MID-CONTINENT AIRPORT 4TH ADDITION
TO WICHITA, SEDGWICK COUNTY, KANSAS

SUB 2000-47 -- One-Step Final Plat of MID CONTINENT AIRPORT FOURTH ADDITION

STAFF REPORT

CASE NUMBER: SUB 2000-47 -- MID CONTINENT AIRPORT 4th ADDITION

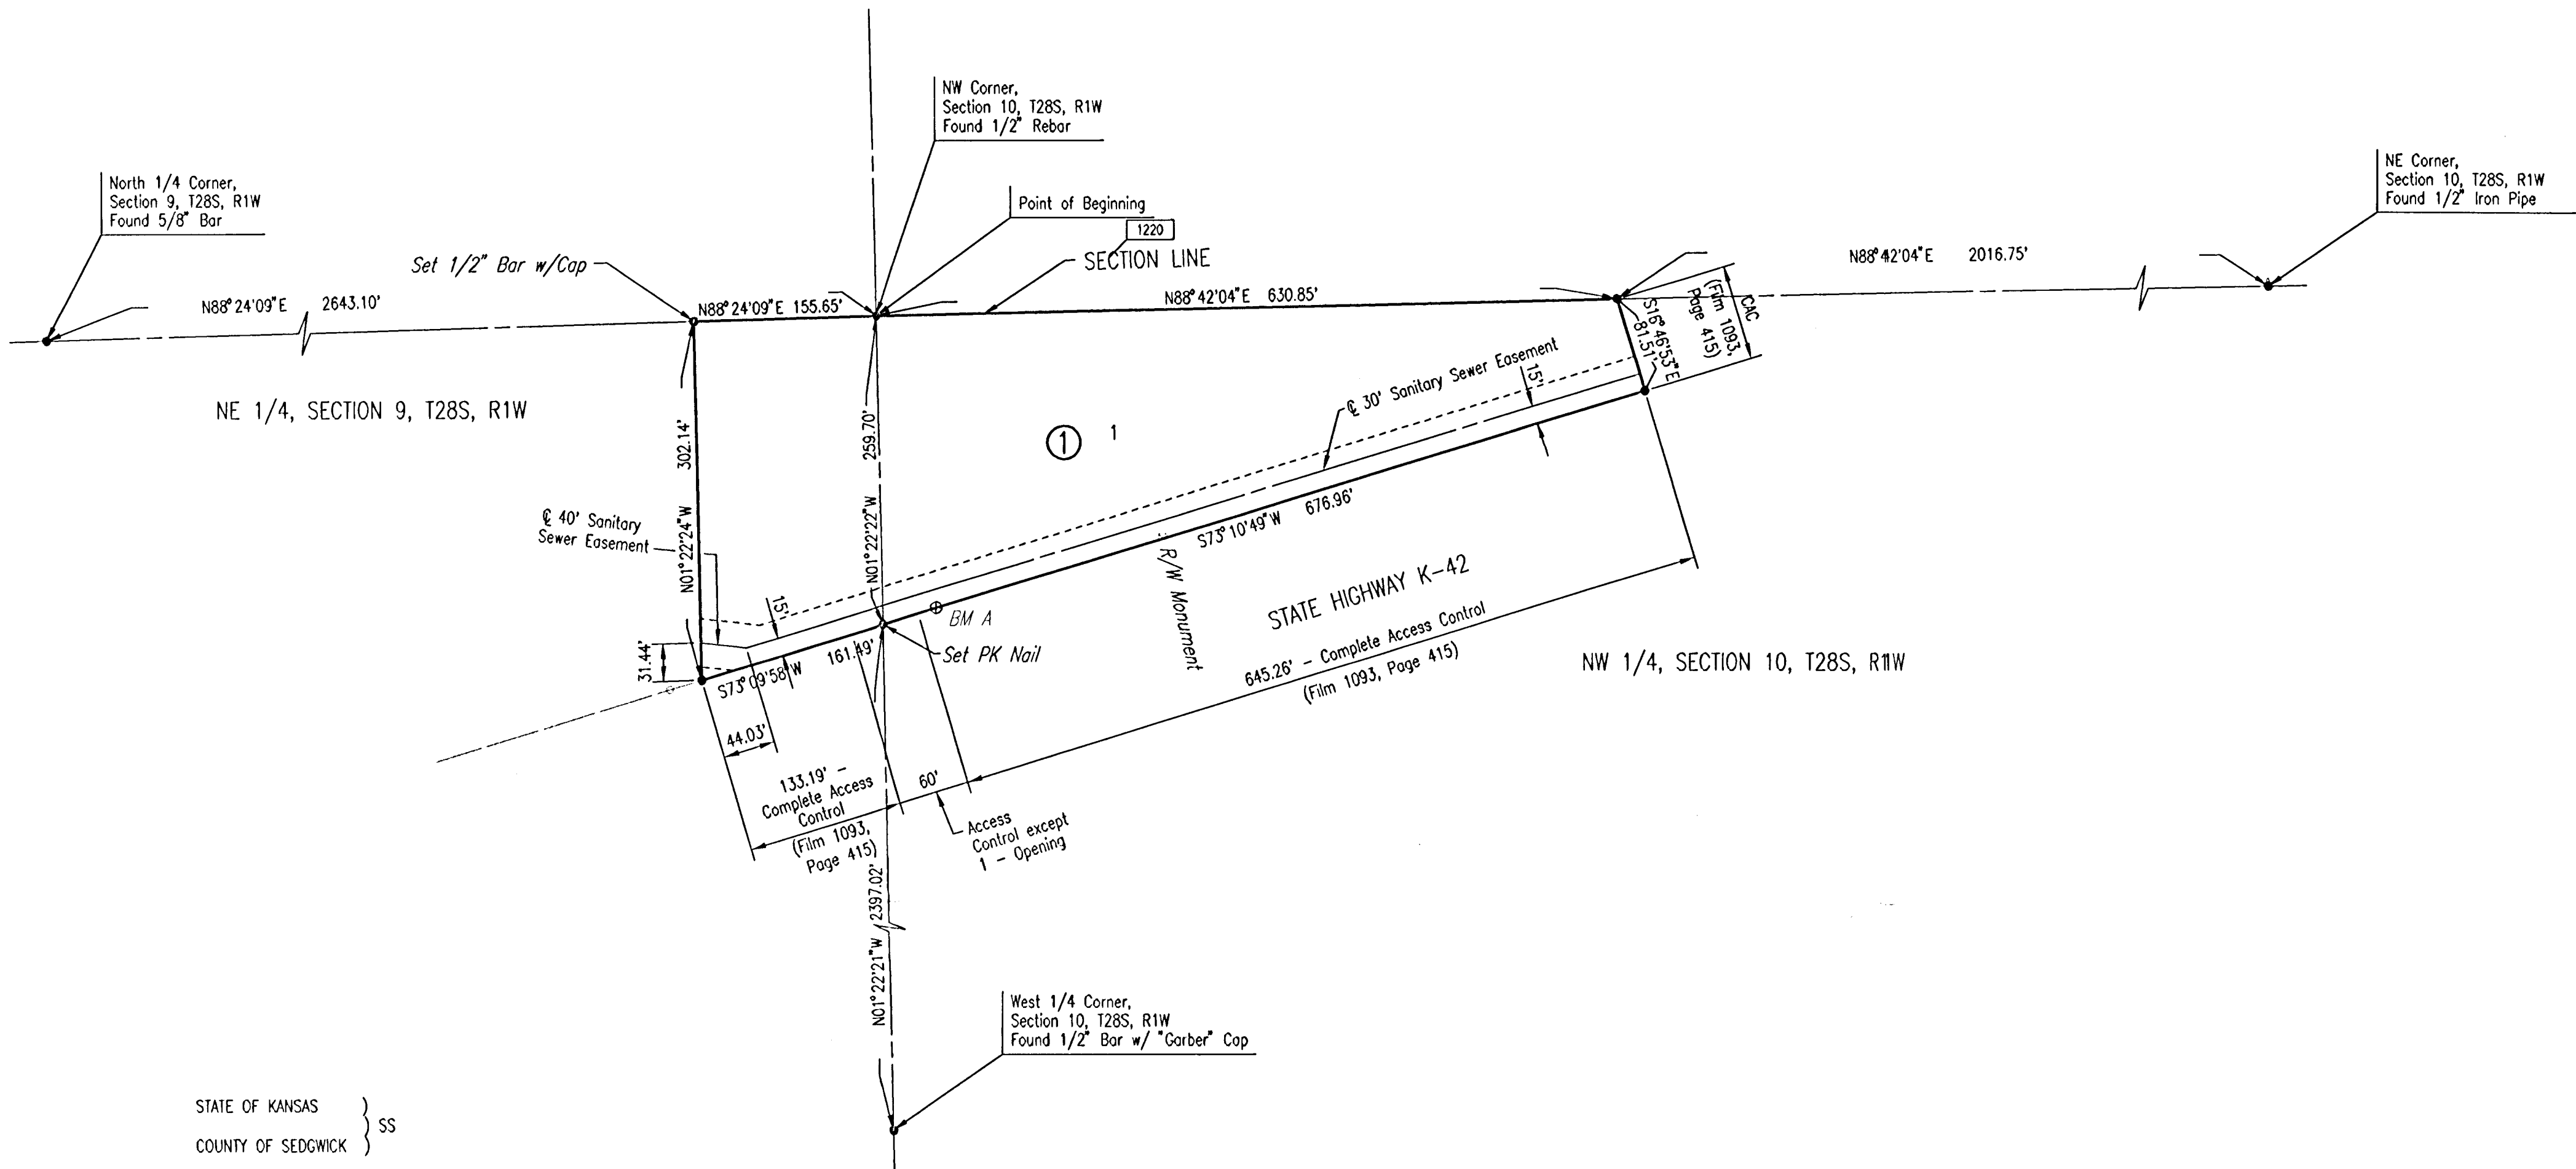
- C. City Engineering needs to comment on the status of the applicant's drainage plan. The drainage plan is approved.
- D. KDOT needs to comment on the access controls. The plat indicates one opening along K-42 Highway. KDOT has approved the opening.

- E. The applicant shall submit an avigational easement covering all of the subject plat and a restrictive covenant assuring that adequate construction methods will be used to minimize the effects of noise pollution in the habitable structures constructed on subject property.

- F. The plat's text shall include language that a drainage plan has been developed for the plat and that all drainage easements, rights-of-way, or reserves shall remain at established grades or as modified with the approval of the applicable City or County Engineer, and unobstructed to allow for the conveyance of stormwater.
